Re: *Application of Virginia Electric and Power Company, For approval and certification of the Coastal Virginia Offshore Wind Commercial Project and Rider Offshore Wind, pursuant to § 56-585.1:11, § 56-46.1, § 56-265.1 et seq., and § 56-585.1 A 6 of the Code of Virginia, Case No. PUR-2021-00142*

STAFF TESTIMONY REFILED

**PREFILED TESTIMONY
OF
KATYA KULESHOVA**

Figure 1: Basic CVOW Commercial Project Components

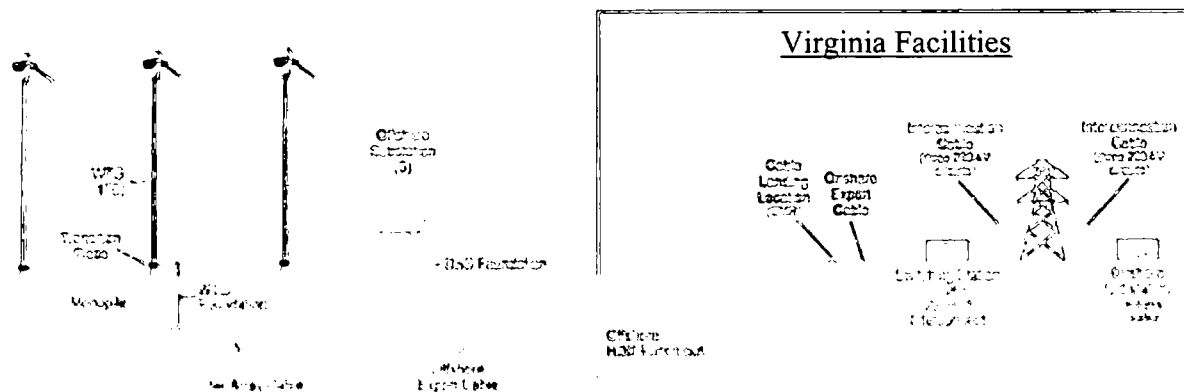
1 Q. PLEASE RECONCILE THE COST OF THE ONSHORE VIRGINIA FACILITIES
2 WITH THE TOTAL ONSHORE ELECTRICAL INTERFACE COST.

3 A. The Virginia Facilities are shown in the red frame in the figure below.⁹⁵

4
5 The estimated conceptual cost of the Virginia Facilities is approximately \$1.1
